2014 WORK ZONE SAFETY REVIEWS

Connecticut Department of Transportation

CONNECTICUT 2014 WORK ZONE SAFETY REVIEW REPORT

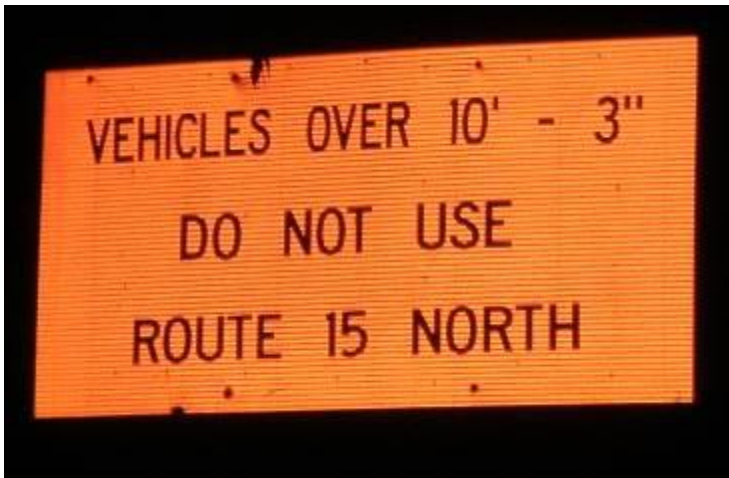
1. At northbound on ramp 36, there were construction equipment hanging over the right shoulder. Also construction workers were moving in and out of the right shoulder. The right shoulder was not safe for motorists. Therefore, it should have been closed to protect construction equipment and construction workers. Refer to the M&PT special provision for typical shoulder closure plans.
2. During the review, it was unclear if the work zones were too closely spaced. Except when a 3-mile work zone has been reviewed and allowed by Construction, the following language is included in the Prosecution & Progress special provision: "The Contractor will not be allowed to have more than 2 work zones on Route 15 in each direction at a time. Each work

zone shall be 1.5 miles or less with a minimum of one mile of open roadway between the work zones. The one mile clear area length shall be measured from the end of the first work area to the beginning of the signing pattern for the next work area”.
